From: C-NLOPB Consolidated Review Comments – Dec 19, 2023 (Blue represents new information from Round 1 Review Comments and Responses)

Fisheries and Oceans Canada (DFO)

Review of Cenovus Responses to Round One Comments:

Figure 1 >5% Oxygen Depletion Risk (Figures from SINTEF)

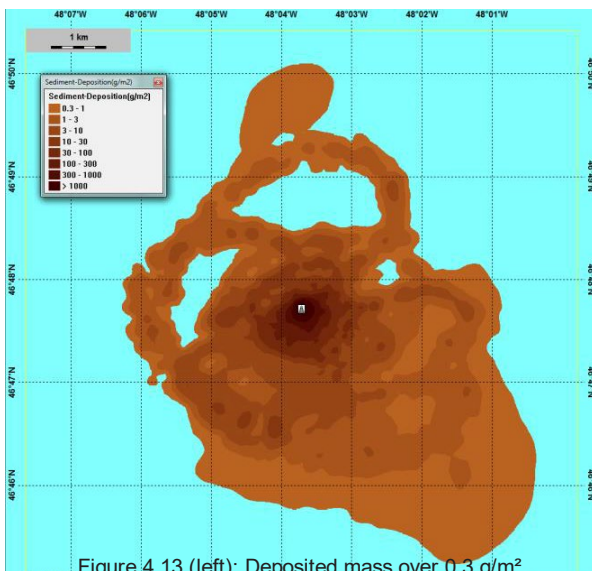
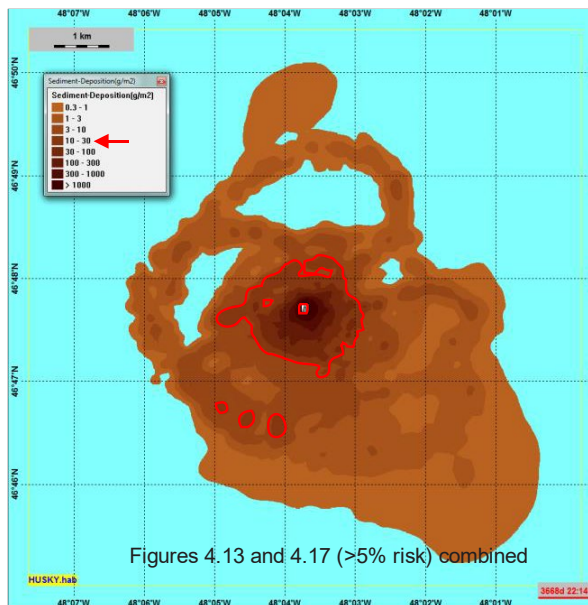
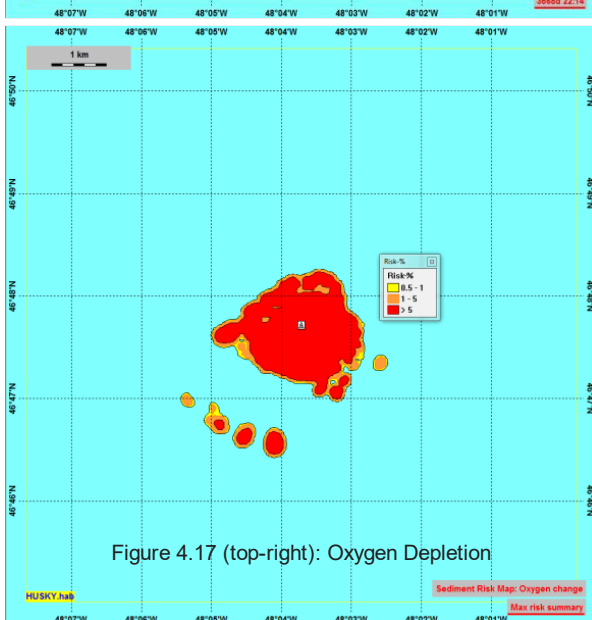
“ The outcome of the SINTEF modelling predicted that, for SBM cuttings treated with Shaker + Dryer +centrifuge, most (89.4 %) threat comes from oxygen depletion related to biodegradation of chemicals in areas with cuttings deposition $> 0.3 \text{ g/m}^2$ and that this effect may extend up to 1000 m from the origin for a 40 well program”.

Is this statement referring to Figure 6.3 in Section 6.3 (page 53), which illustrates deposition mass from repeated drillings (results from the model postprocessed for repeated drillings)? In Figure 6.3, deposition mass above 0.3 g/m^2 ($< 1 \text{ kg/m}^2$ from the Figure scale) extends 1 km from the center when drilling 1 well was modelled; deposition mass above 0.3 g/m^2 extends more than 2 kms from the center for 40 wells. Statement should be updated to indicate which section/figure(s) from the SINTEF modelling report is being referred to and accurately characterize results for a 40 well program.

Please include details on why 0.3 g/m^2 was selected as the threshold for oxygen depletion in the EA Amendment.

This statement is not referring to SINTEF Figure 6.3 in Section 6.3 (page 53), but rather Section 4.2 Sea Floor Results (page 38) in which Scenario 2 – 5.5% SOC is presented. The following figure superimposes Figure 4.13 – Deposited Mass Over 0.3 g/m^2 with Figure 4.17 (t-r) Maximum Risk for Oxygen Depletion. The $>5\%$ risk zone for oxygen depletion (total EIF contribution = 89.42%) extends to the perimeter of the 10 to 30 g/m^2 sediment deposition zone rather than the $>0.3 \text{ g/m}^2$ zone as was implied in the original submission. The 10 to 30 g/m^2 extends approximately 1,000 m from the platform.

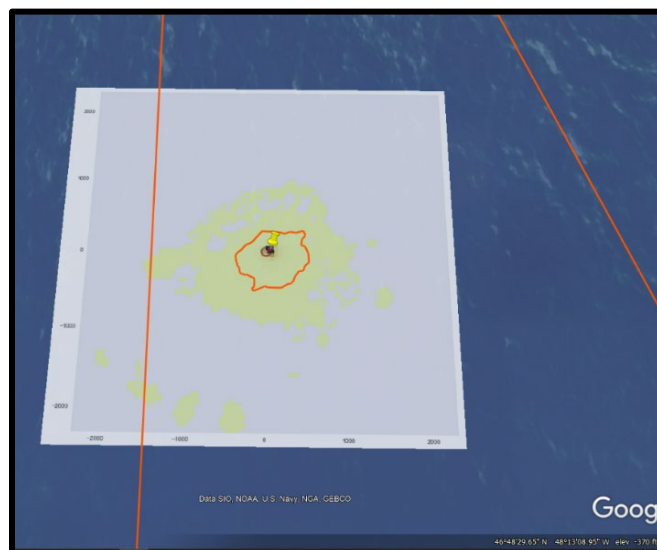
“The affected area is around the discharge location within a radius of approximately 1 km”

When referring to “affected area”, it should be clarified what drill cutting deposition thickness and number of wells were taken into account. As noted above, DFO is interested in the 1.5 and 6.5 mm thresholds for 40 wells. Revisions recommended.

The EA Amendment uses EEM data to determine environmental effects. The affected area, or zone of influence as referred to in an EA and EEM program, is not based on deposition thickness but rather, is based on the extent of effects to the benthic community. Results from the 2022 EEM indicate that there was evidence of project effects on benthic biomass near active drill centres and little to no evidence of effects on total abundance and richness. Decreases in biomass near active drill centre were related, in part, with decreases in the number of larger echinoderms.

Deposition Mass from 1 drilling operation. Straight red line is Safety Zone boundary. Red circle is the 6.5-0.1 mm thickness boundary (Figure 4.11) from Section 4.2.

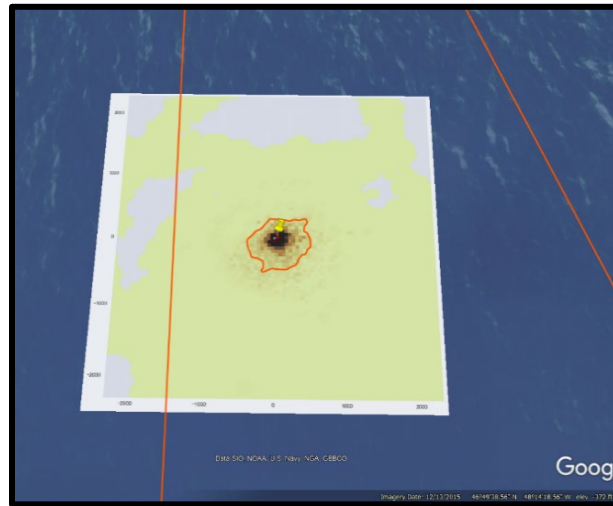
“The SINTEF model indicates that the extent of the drill cuttings at 0.1 mm depth do not extend beyond the White Rose Safety Zone (Figure 2.1)”

It is possible that drill cutting deposition at 0.1 mm may extend to the boundary or slightly beyond the safety zone after drilling 40 wells (see images below of sections from Figure 6.4, Section 6.2 – page 54 overlain on Google Earth). In the Wood report, considering the mean deposition thickness, 0.7mm extends out to 10-16km (Table 5-2, page 27). This would also be outside of the safety zone. The EA Amendment should be revised to reflect a 40 well program (with consideration of results from the Wood report).

As noted above, DFO is interested in the 1.5 and 6.5 mm thresholds for 40 wells. These thresholds do NOT extend beyond the White Rose Safety Zone and the 0.1 mm only extends to the boundary or slightly beyond the White Rose Safety Zone. The White Rose Field does not contain significant benthic habitat, and there are no corals identified in the area. As such, the PNET of 1.5 mm (pertaining to corals) and 6.5 mm (pertaining to significant benthic habitat) are not applicable to the White Rose Field.
